APPEAL SUMMARY

Appeal ID: 26439	Project Address: 3145 NE 55th Ave
Hearing Date: 1/26/22	Appellant Name: Joe Robertson
Case No.: B-002	Appellant Phone: 9712353675
Appeal Type: Building	Plans Examiner/Inspector: Derek Wildermuth
Project Type: residential	Stories: 1 Occupancy: Residential Construction Type: Wood - Residential
Building/Business Name: Shelter Solutions LLC	Fire Sprinklers: No
Appeal Involves: Alteration of an existing structure	LUR or Permit Application No.:
Plan Submitted Option: pdf [File 1] [File 2] [File 3] [File 4] [File 5] Proposed use: Detached Studio/Bedroom

Garage conversion to living space with alternate one hour exterior wall assembly at South and West sides within three feet of property line: Granted provided:

JACOBS STUDIO / BEDROOM
3145 NE 55TH AVE
SITE PLAN

Where roof framing is parallel to the wall.

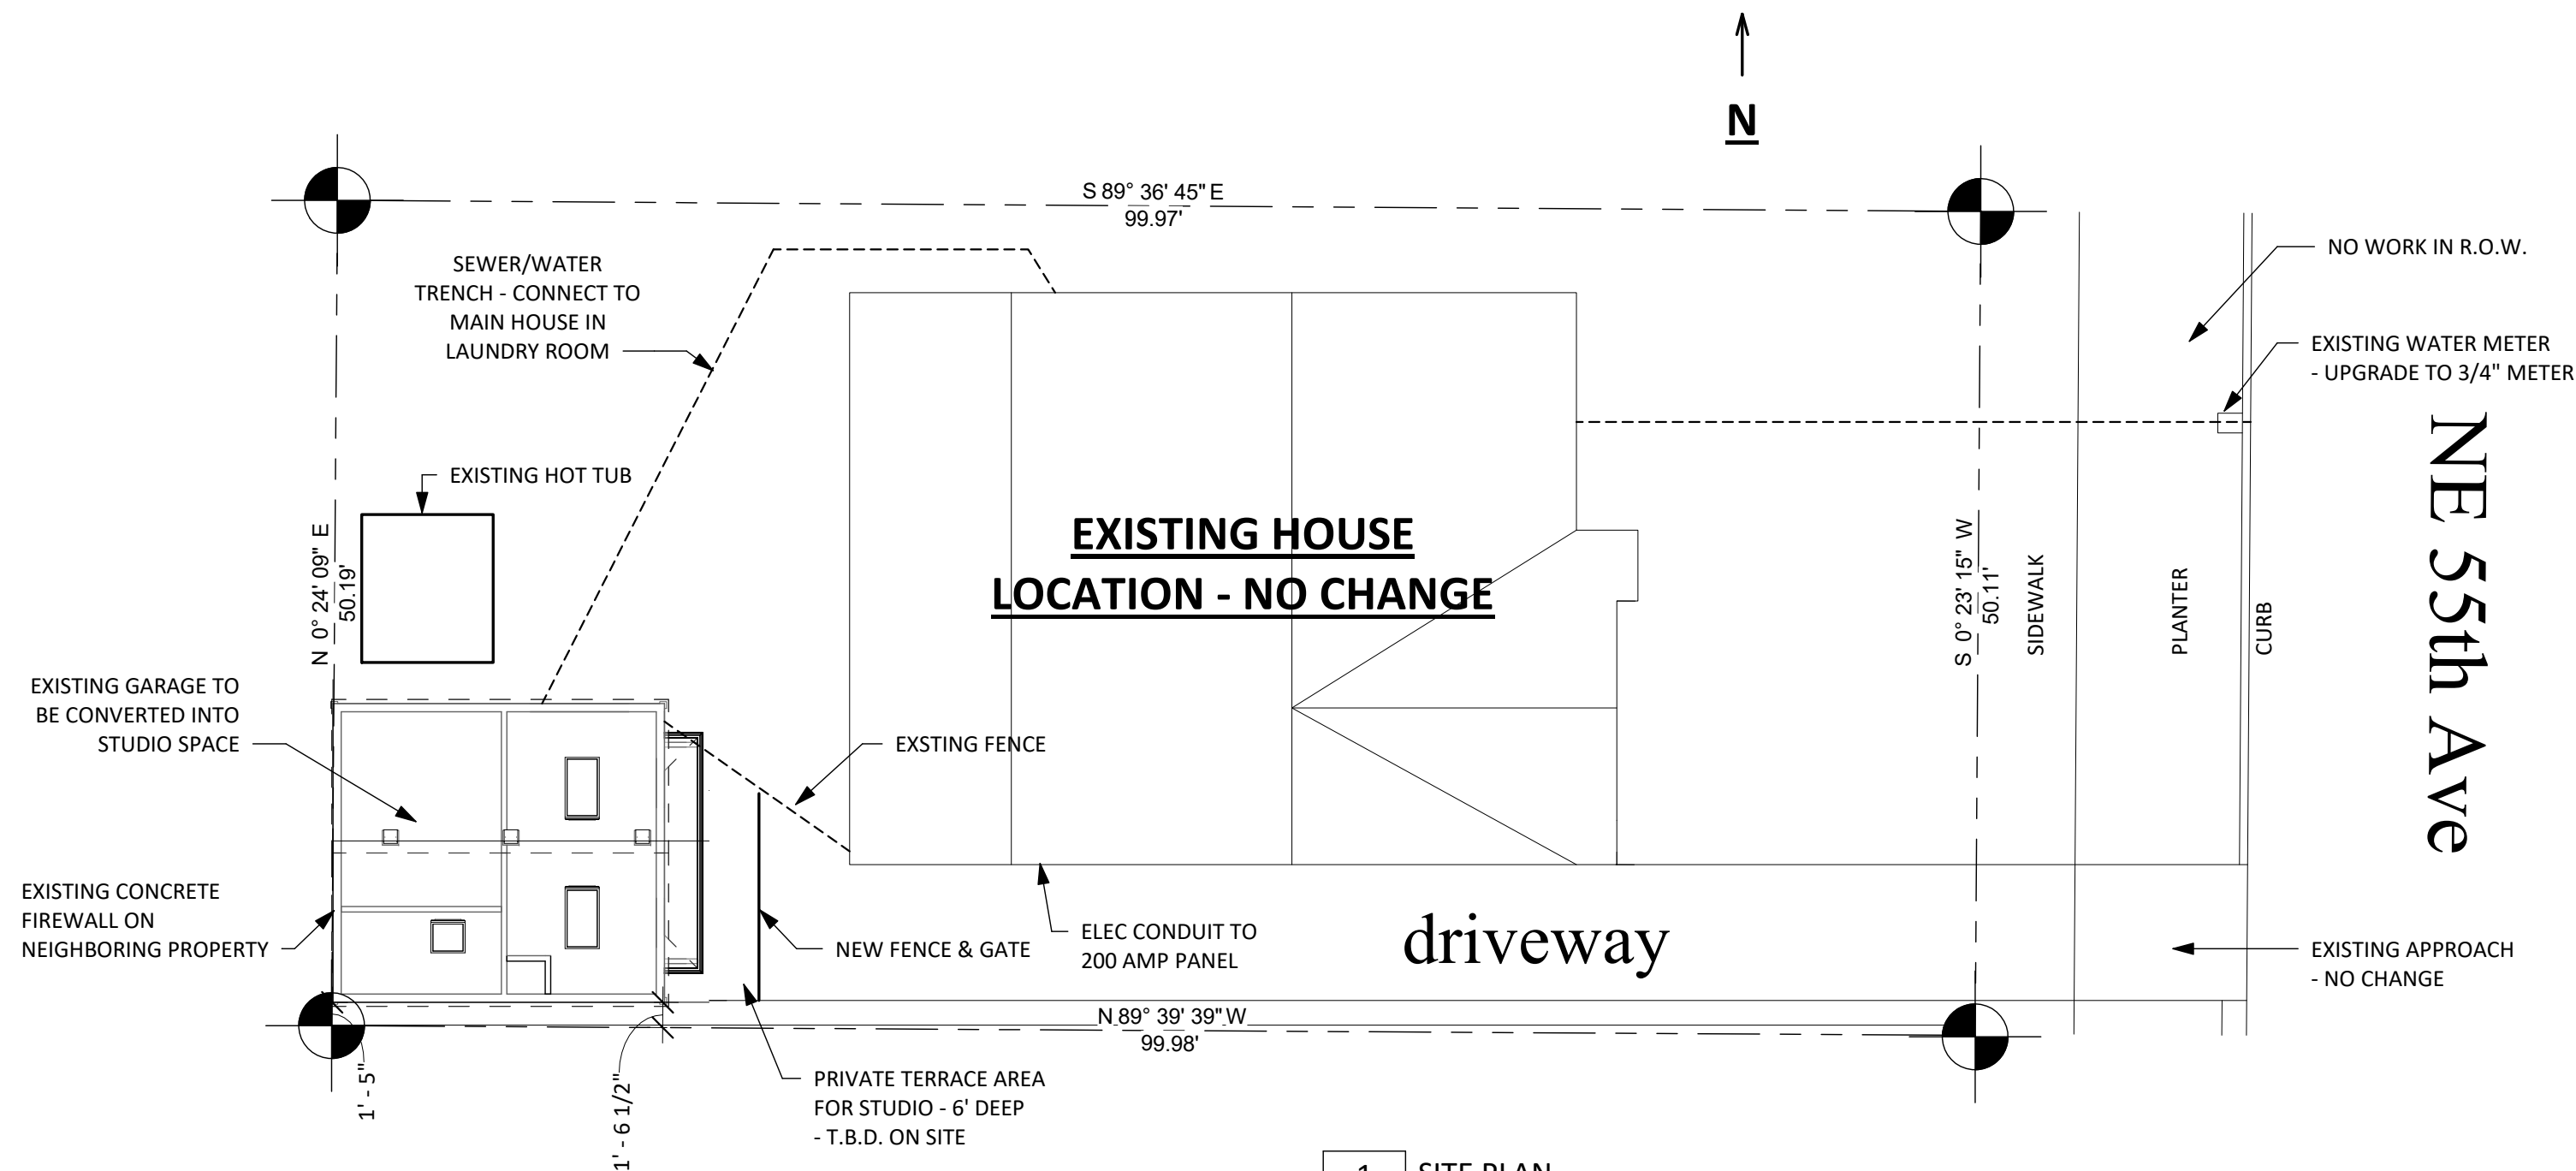
Where roof framing is perpendicular to the wall.

- a. Two layers of Type X gypsum are installed on the interior side of the wall continuous to the top of the double top plate.**
- b. Two layers of 2x blocking are provided between the top of the double top plate and underside of the roof sheathing, beveled where required, to fit tight against the sheathing.**

- c. The underside of the roof adjacent to the property line is provided with one layer of 5/8" Type X gypsum board installed directly against the underside of the roof sheathing between the roof joists or trusses with support provided by a minimum of 2 x ledgers attached to the side of the roof joists or truss members for a minimum distance of four feet measured from the inside face of the finished wall surface.**

- d. No openings including eave vents may be installed in the soffit and no openings including windows, roof vents or skylights may be installed in that portion of the wall or roof that is within three feet of the property line.**

- e. No built elements including gutters and footings may cross the property line and stormwater must remain and be disposed of on site.**

Same as above except at condition (a) the Type X is continuous to the bottom of the roof sheathing and condition (b) may not apply.

JACOBS STUDIO / BEDROOM
3145 NE 55TH AVE
FLOOR PLANS

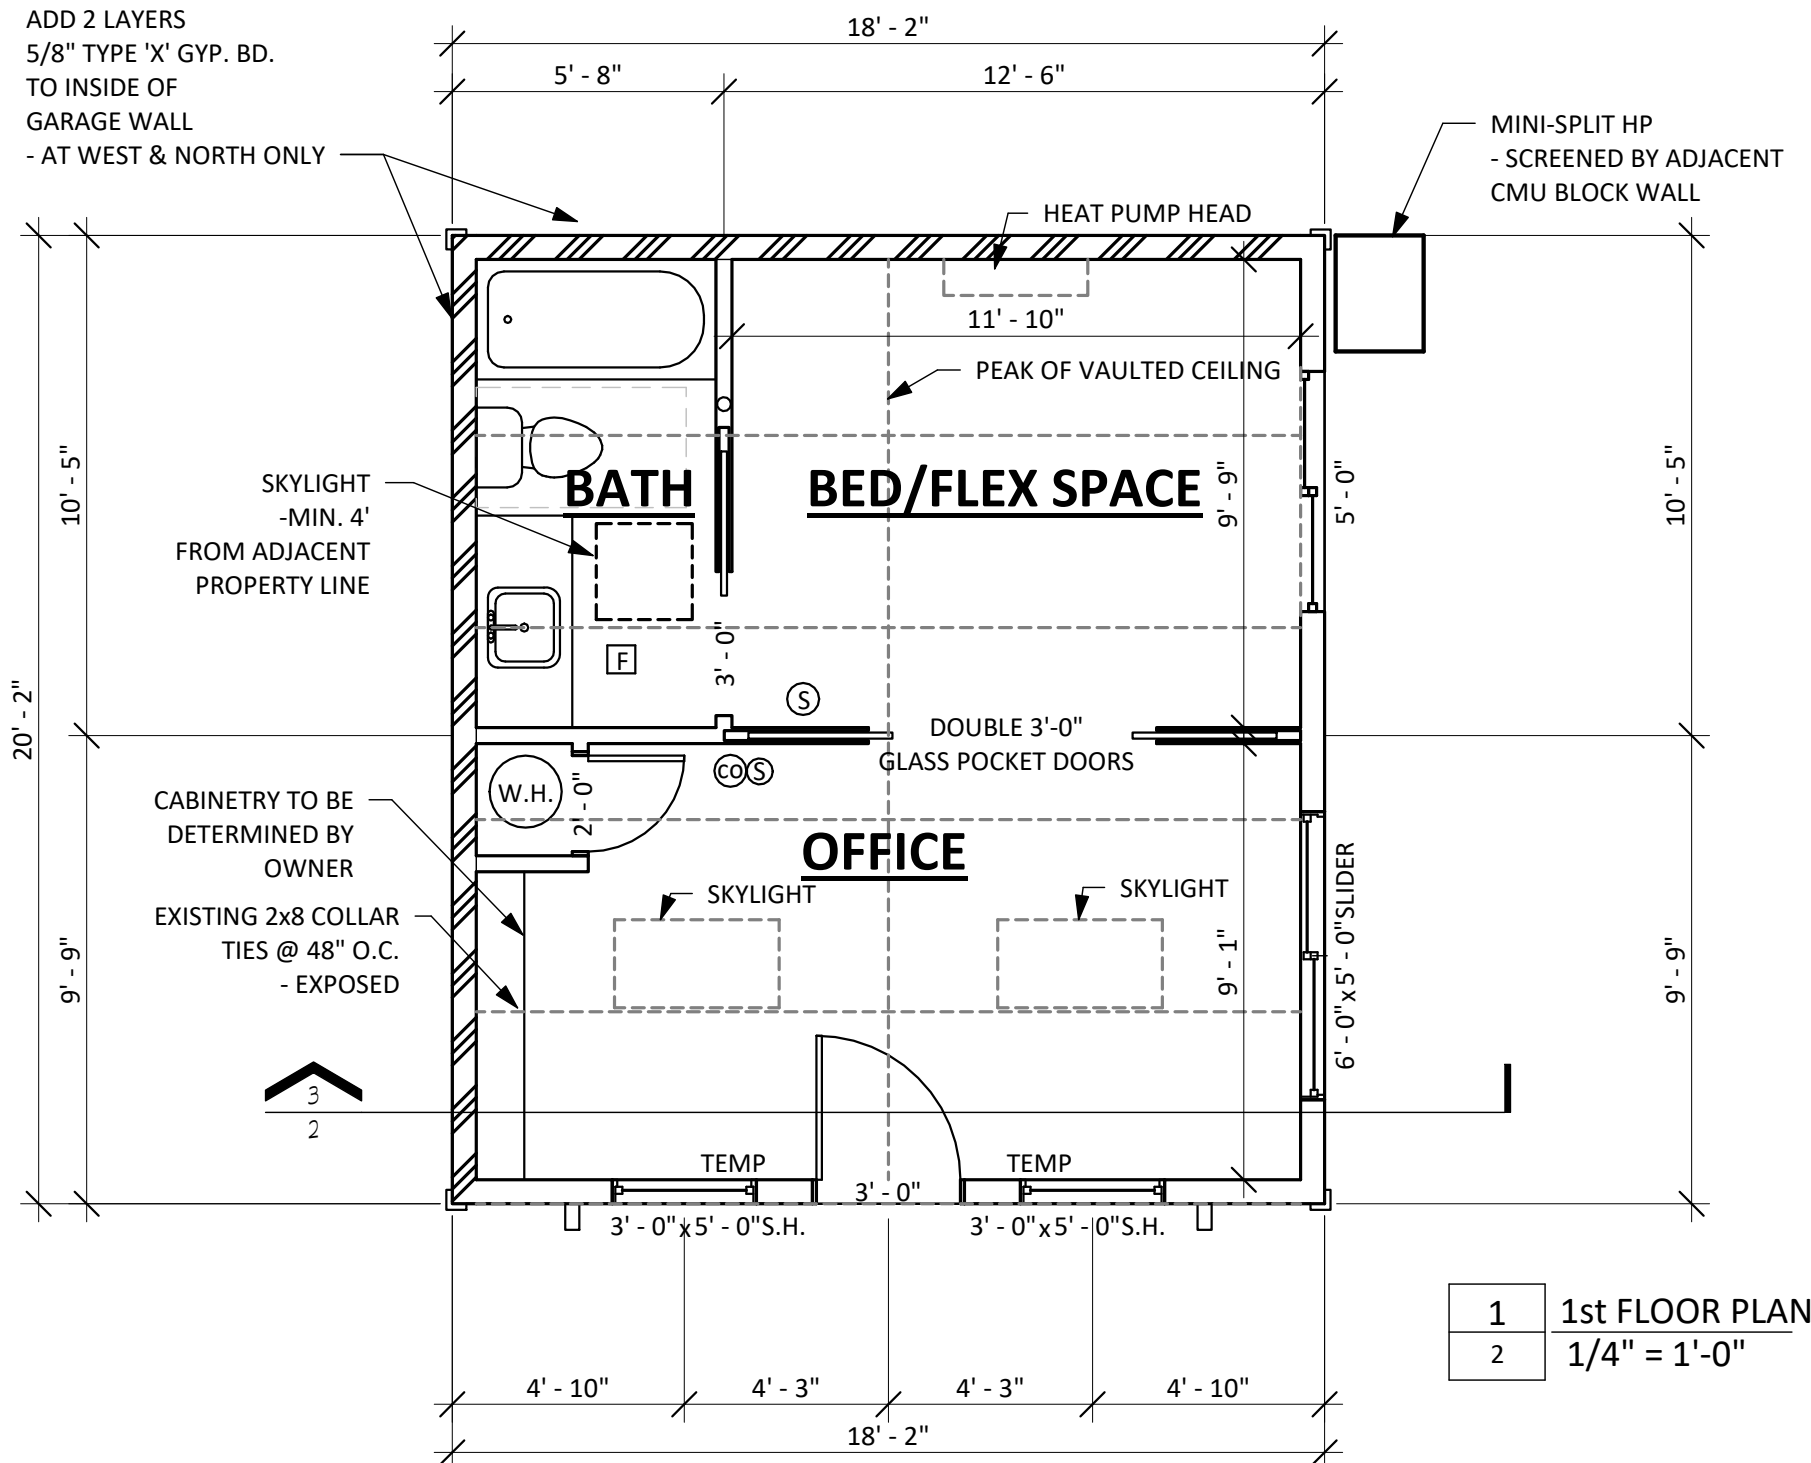
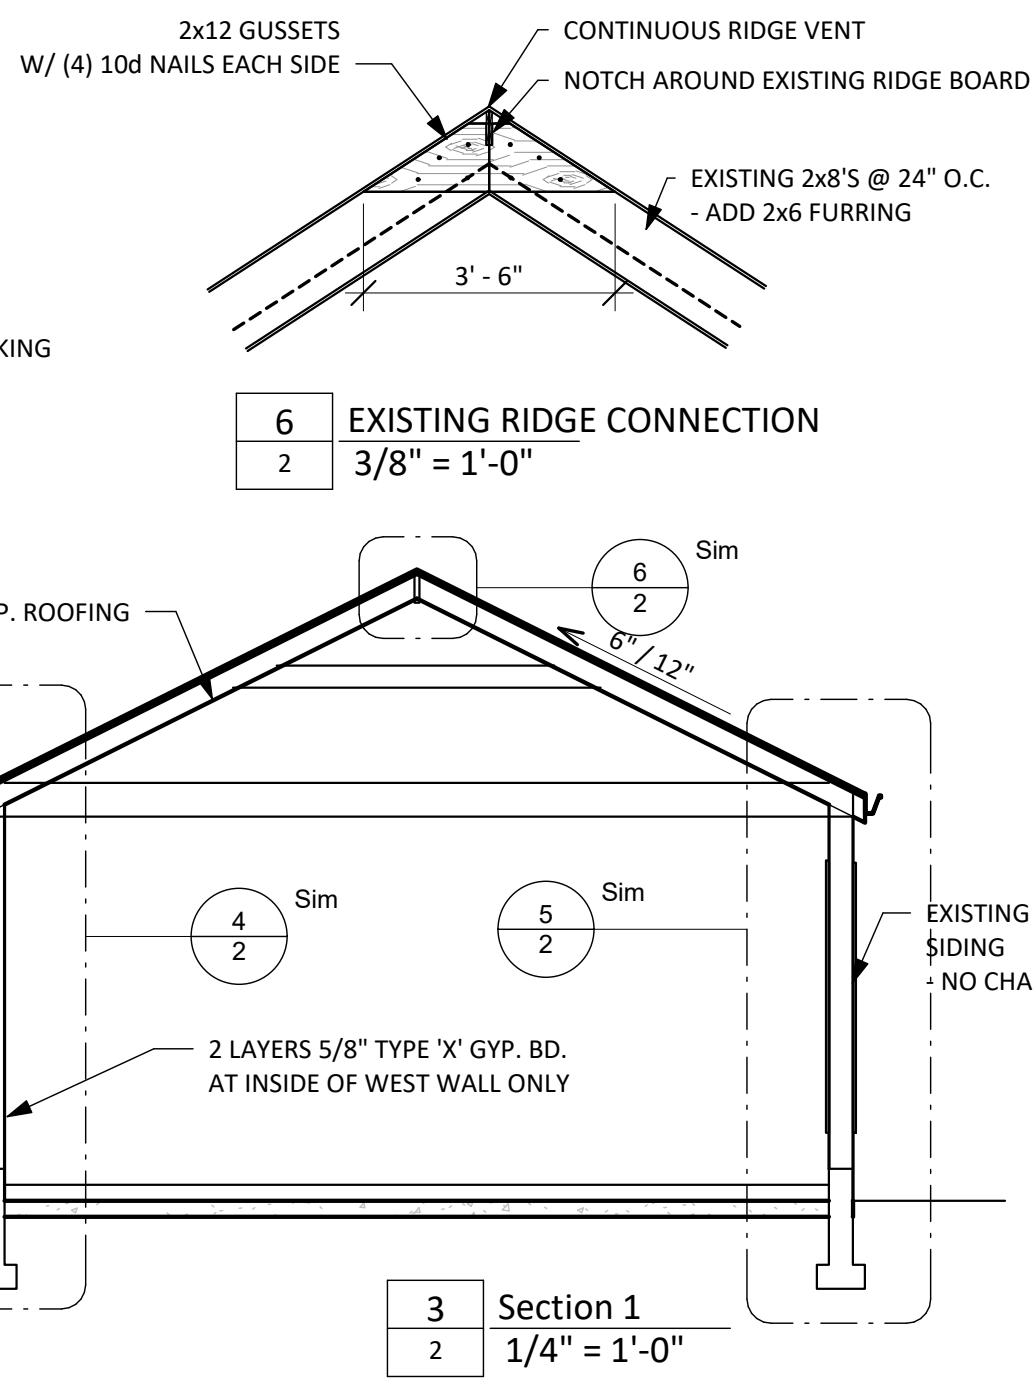
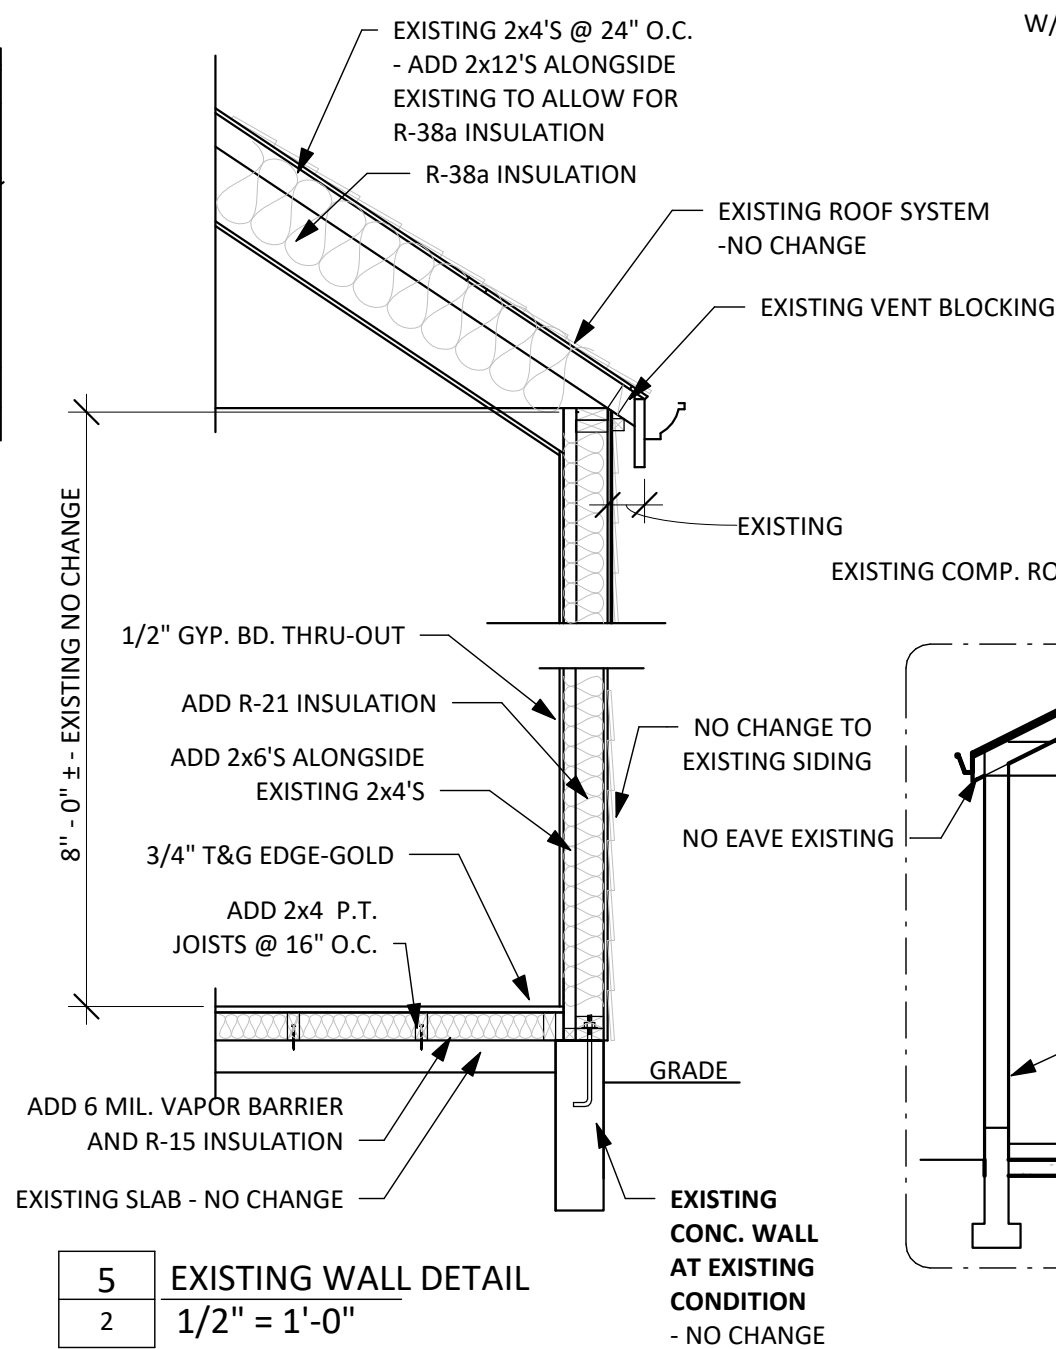
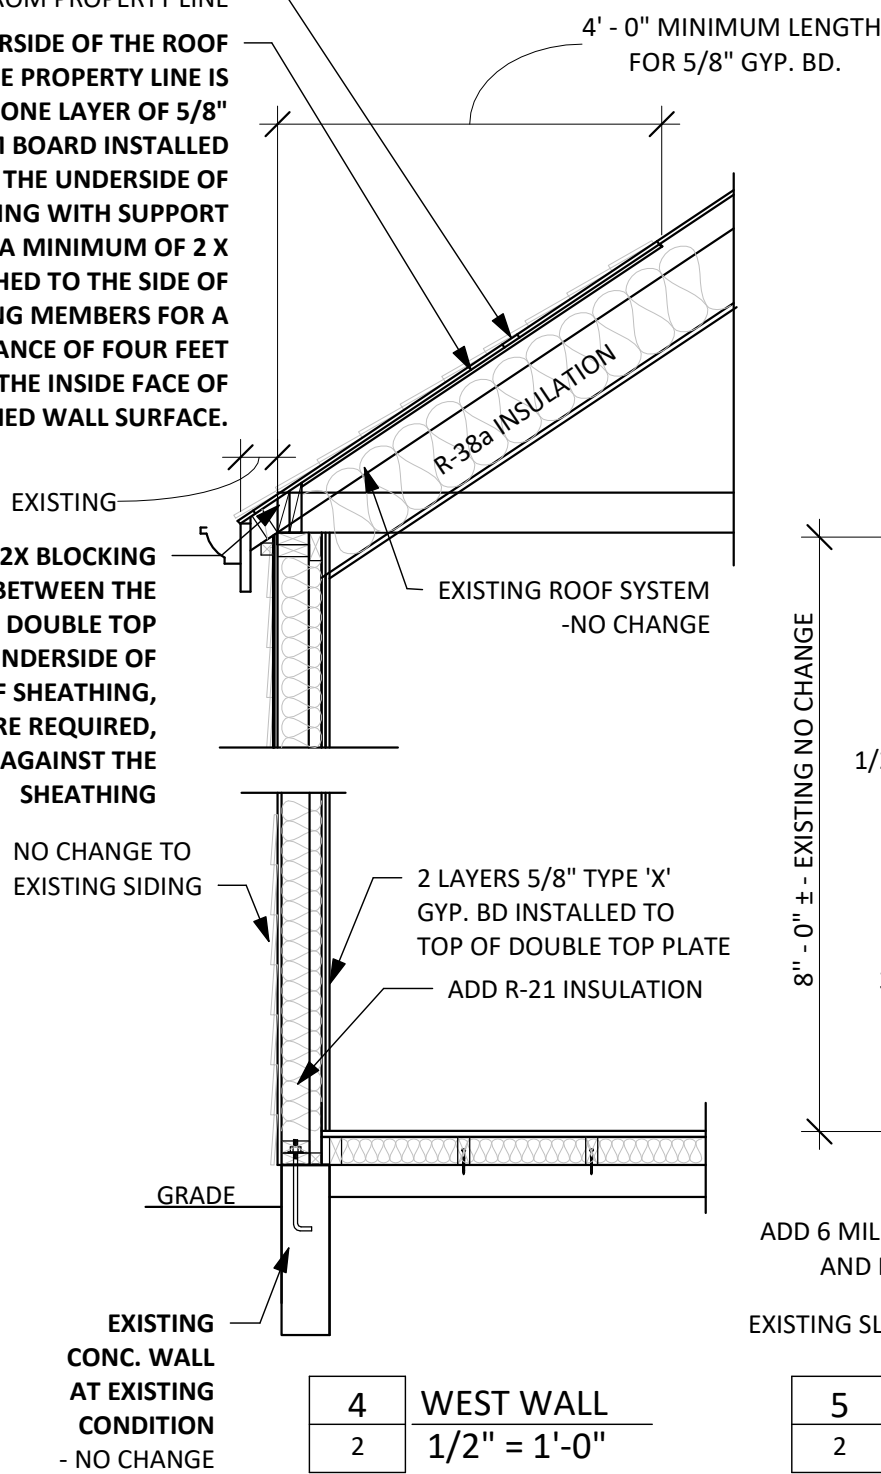
- ADD GAF COBRAPRO INTAKE VENT
AS INDICATED ON ROOF PLAN
- ON WEST SIDE ONLY
- MIN. 3'-0" FROM PROPERTY LINE

THE UNDERSIDE OF THE ROOF
ADJACENT TO THE PROPERTY LINE IS
PROVIDED WITH ONE LAYER OF 5/8"
TYPE X GYPSUM BOARD INSTALLED
DIRECTLY AGAINST THE UNDERSIDE OF
THE ROOF SHEATHING WITH SUPPORT
PROVIDED BY A MINIMUM OF 2 X
LEDGERS ATTACHED TO THE SIDE OF
THE ROOF FRAMING MEMBERS FOR A
MINIMUM DISTANCE OF FOUR FEET
MEASURED FROM THE INSIDE FACE OF
THE FINISHED WALL SURFACE.

**TWO LAYERS OF 2X BLOCKING
ARE PROVIDED BETWEEN THE
TOP OF THE DOUBLE TOP
PLATE AND UNDERSIDE OF
THE ROOF SHEATHING,
BEVELED WHERE REQUIRED,
TO FIT TIGHT AGAINST THE
SHEATHING**
